**FINAL DRAINAGE REPORT  
FOR  
STERLING RANCH RECYCLING FACILITY**

**February 2024  
Project No. 25188.14  
PCD Filing No: PPR2341 & SF2325**

**COST ESTIMATE**

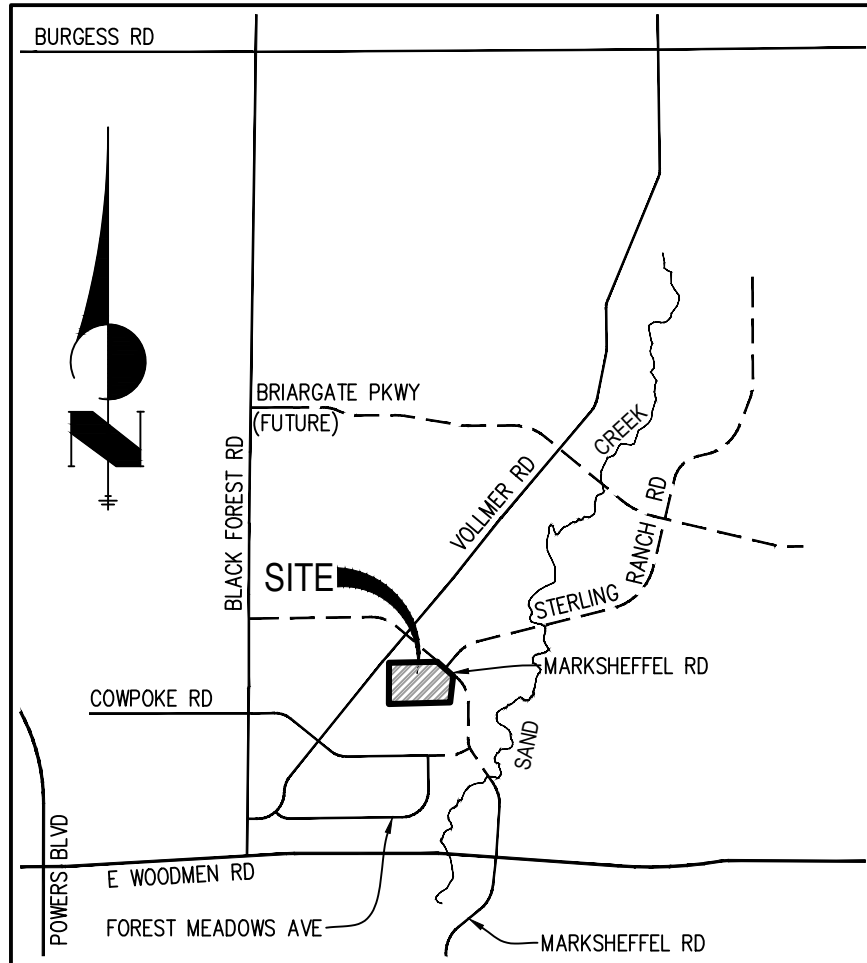
Per my comment on the FAE Form, please provide a separate table that summarizes just the cost of pond components. The total should match what is shown on the FAE Form (currently \$170k). My previous Review 1 comment is provided below for reference.

Include a cost estimate for each PBMP with line items for all components (ex: riprap, road base, forebay, trickle channel, outlet structure, outlet pipe, spillway, etc). Input the total value into the FAE form under "Permanent Pond/BMP (provide engineer's estimate)" in Section 1. The total should not include grading, which is a separate line item in Section 1: "Earthwork."
